**OHIO RIVER BRIDGES  
SECTION 4 - EAST END BRIDGE APPROACH  
VALUE ENGINEERING STUDY REPORT**

**Study Date: December 10 - 14, 2007  
Report Date: January 4, 2008**

**VALUE ENGINEERING STUDY  
for  
Kentucky Transportation Cabinet**

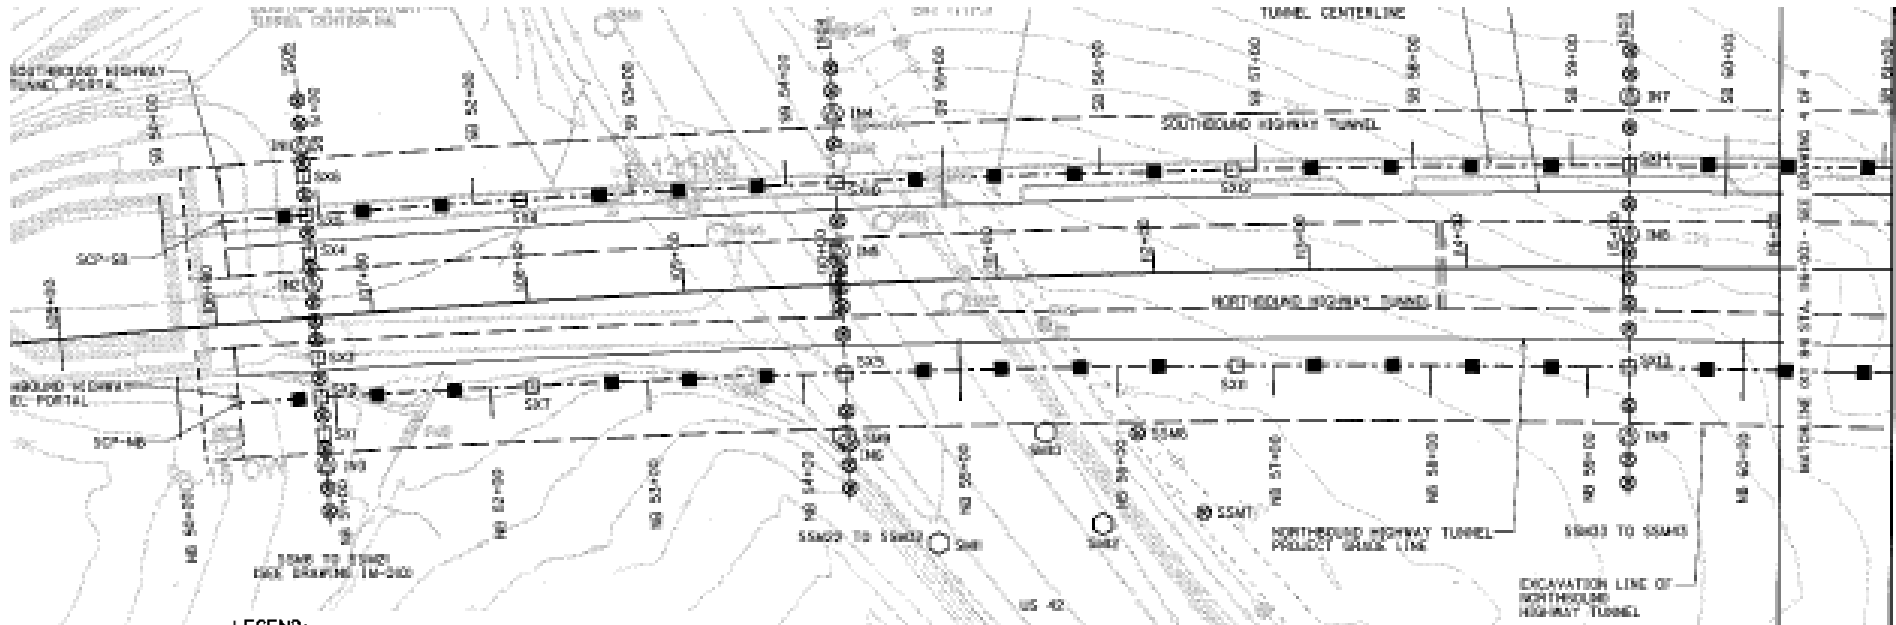
This recommendation will substantially reduce the cost, complexity, and construction time for this project. This will also substantially change the approaches on the south and north sides of the project.

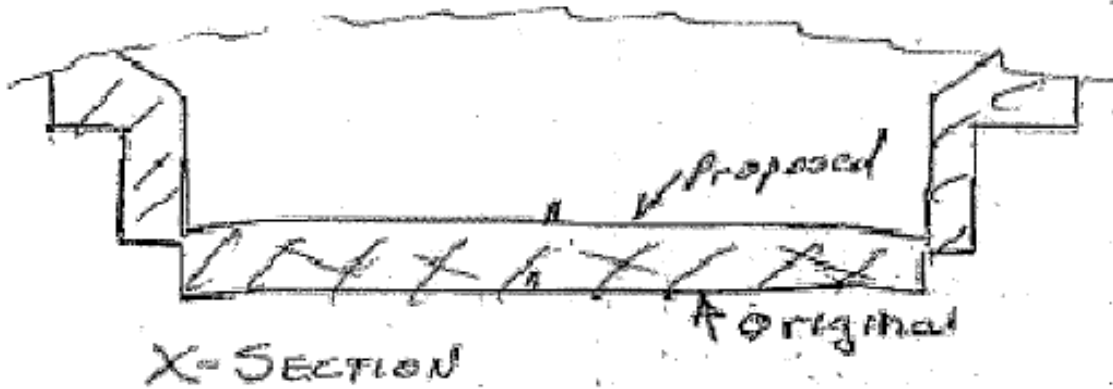
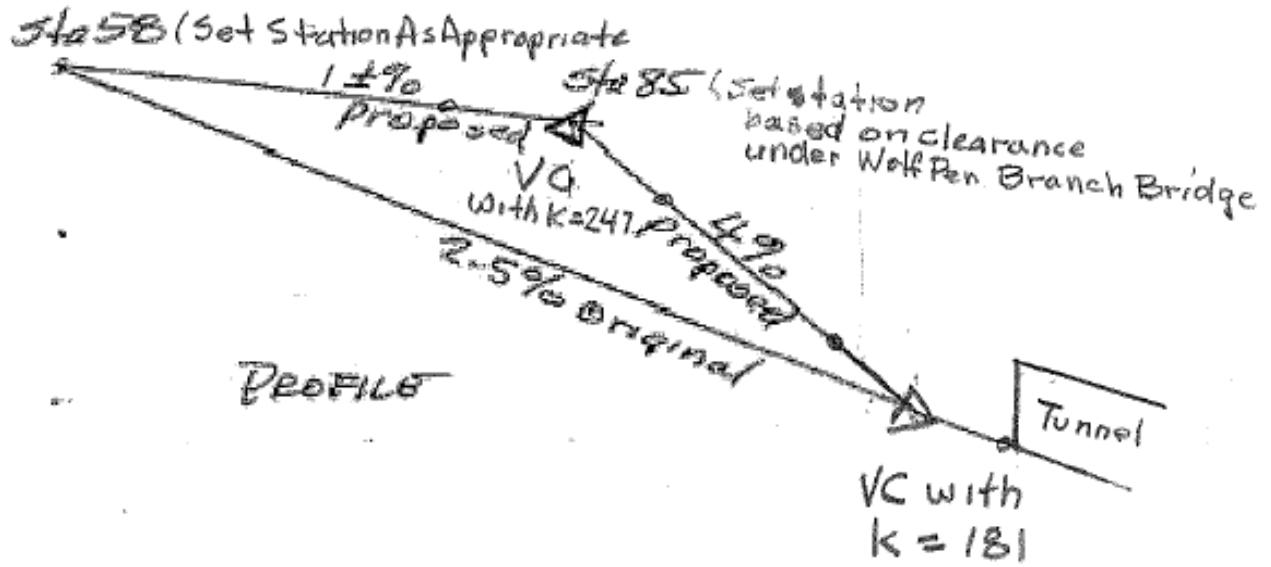
Modify vertical alignments south of the tunnel to increase the grade to 4% from 2.5% in order to reduce excavation. The 4% grade is acceptable for either a 60 mph or 70 mph design speed in this rolling terrain. The 4% grade will be controlled by the need to provide sufficient vertical clearance under the Wolf Penn Branch Road. The vertical curve at the south end of the tunnel will be located to assure that it does not affect the elevations in the tunnel.

- Reduced earthwork
- Reduced retaining wall height for the length of the grade change
- Reduced wasted material
- Meets full AASHTO criteria

VALUE ENGINEERING RECOMMENDATION # VE-10

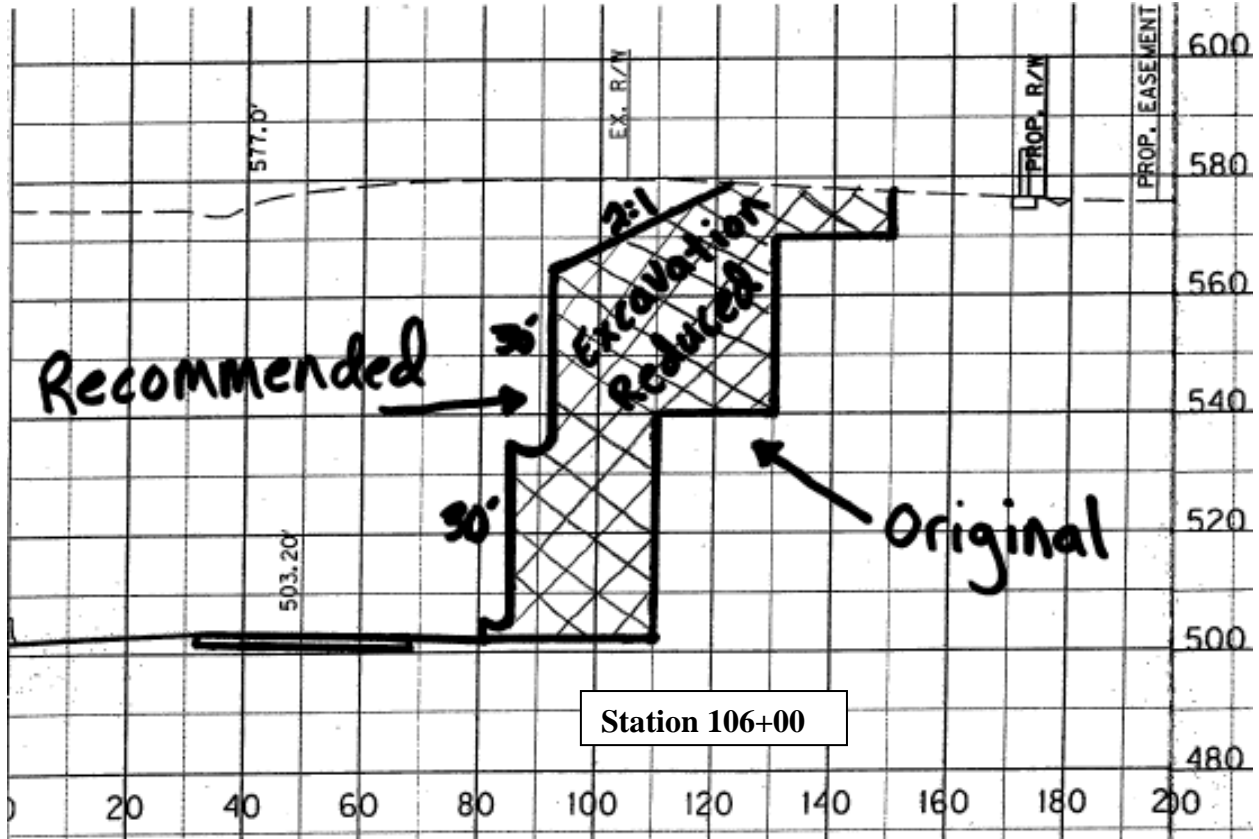
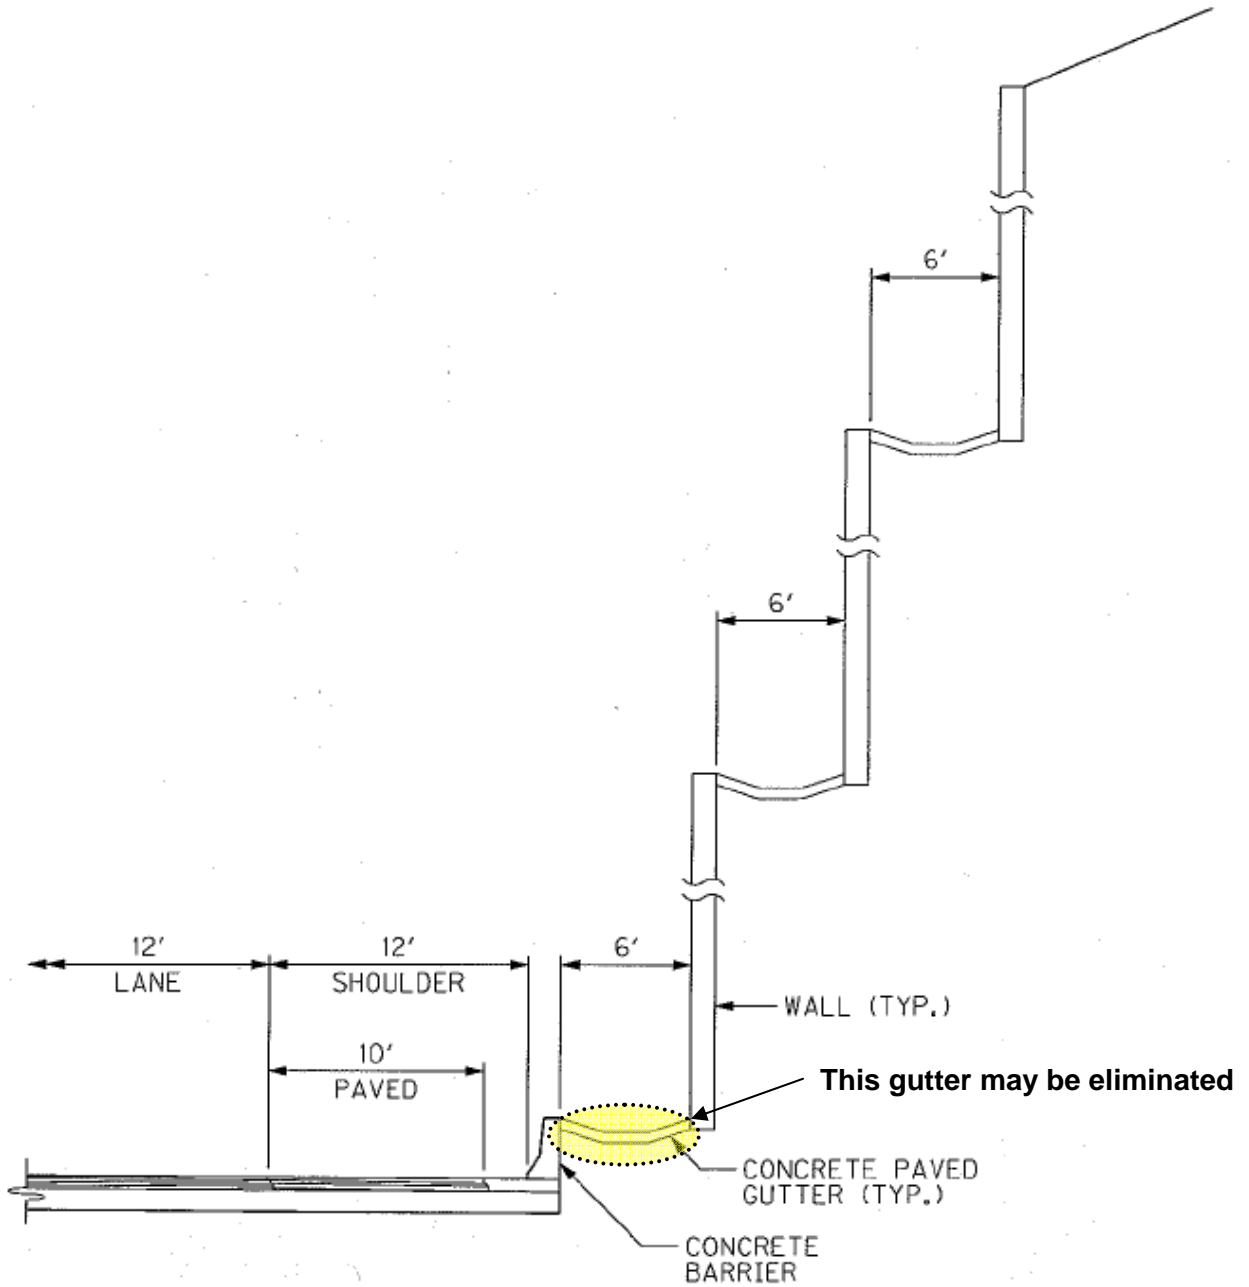
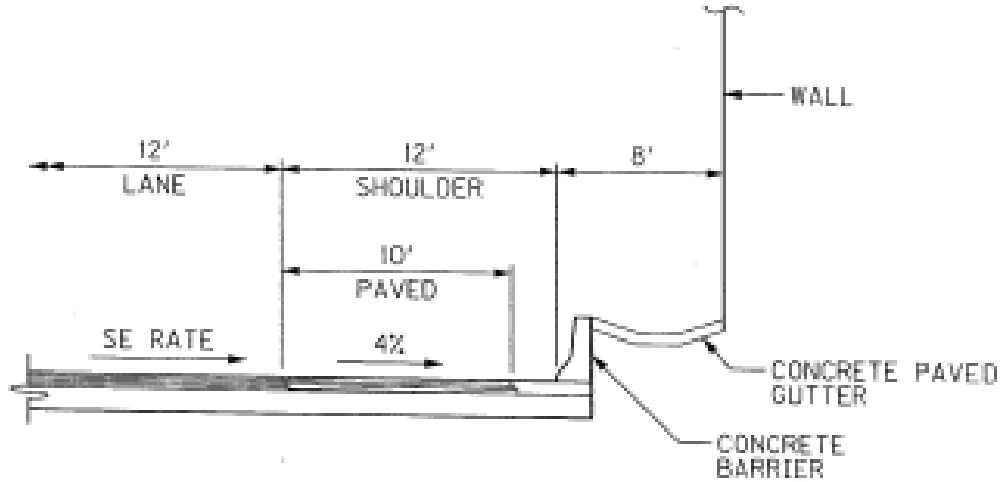
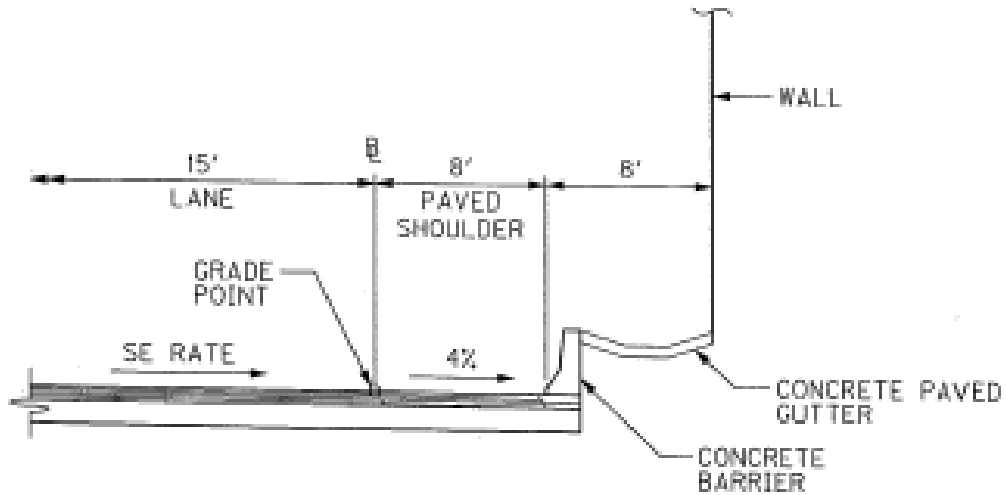
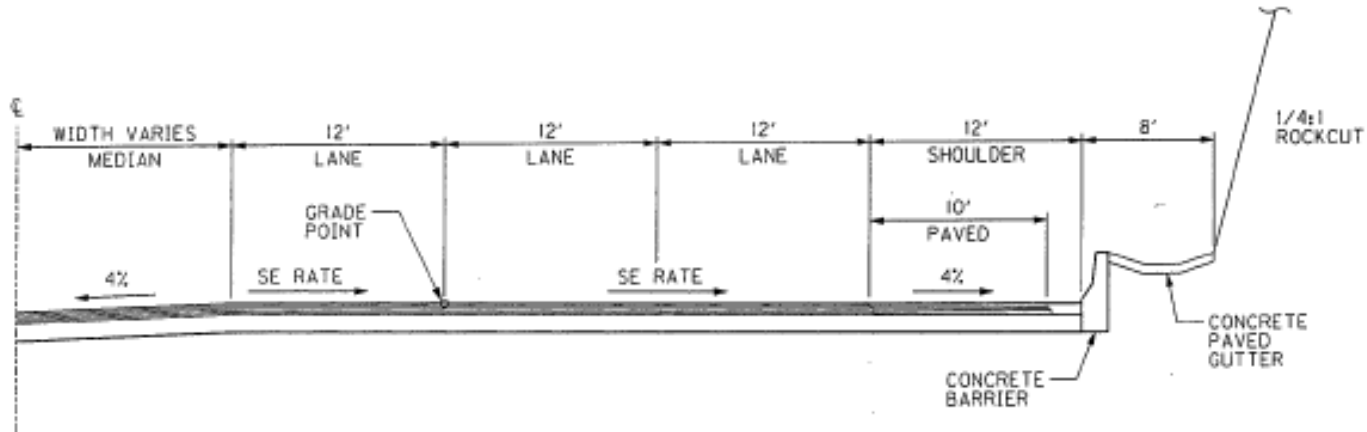
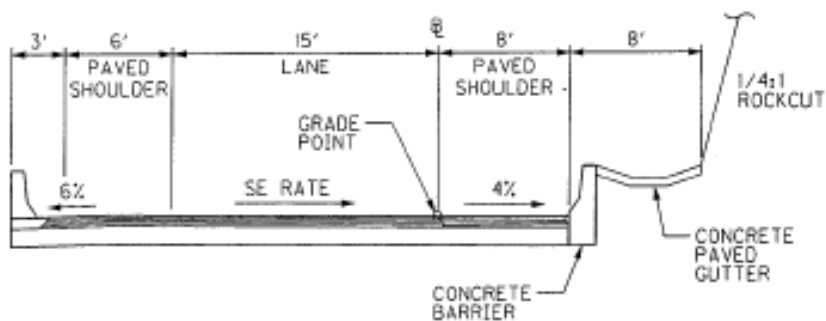
The project has approximately 2 million cubic yards of waste. Approximately 330,000 cubic yards of this material would not have to be excavated with this revised section. It can also be assumed that there will be a significant reduction in the retaining walls.

# VALUE ENGINEERING RECOMMENDATION # VE-11

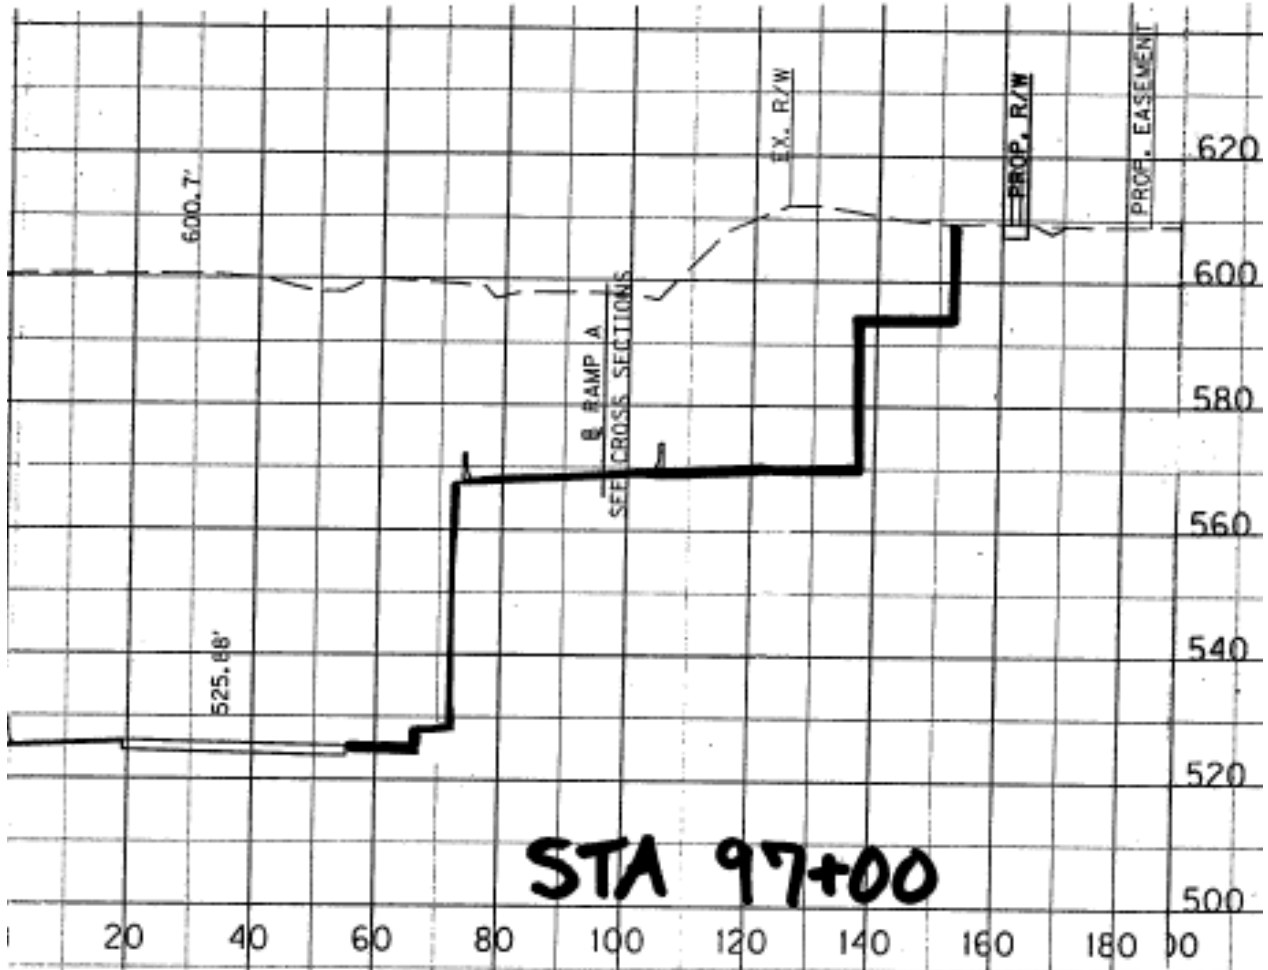
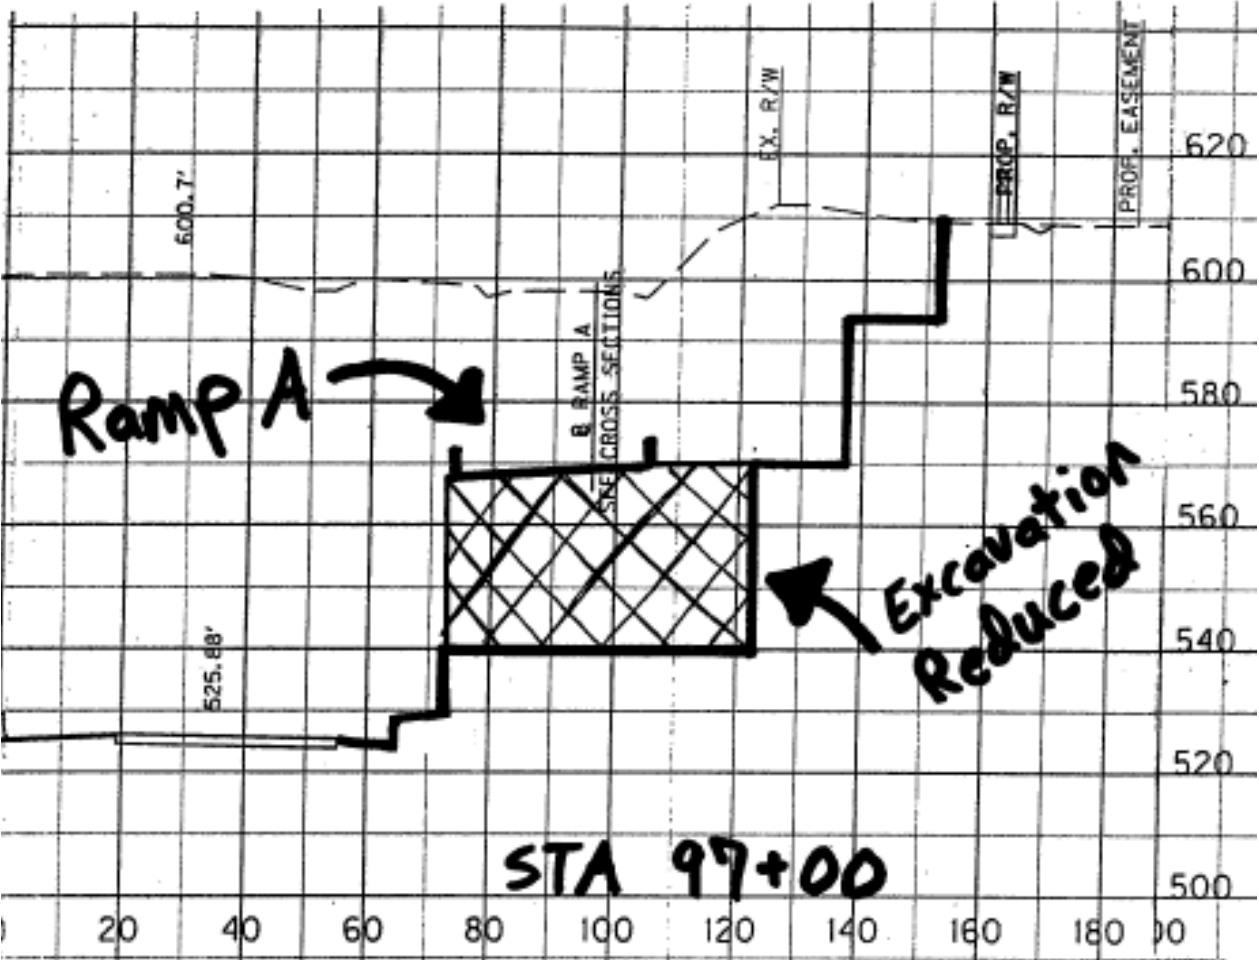
- Reduce the length of the bridge
- Reduce the maintenance by reducing the length of bridge
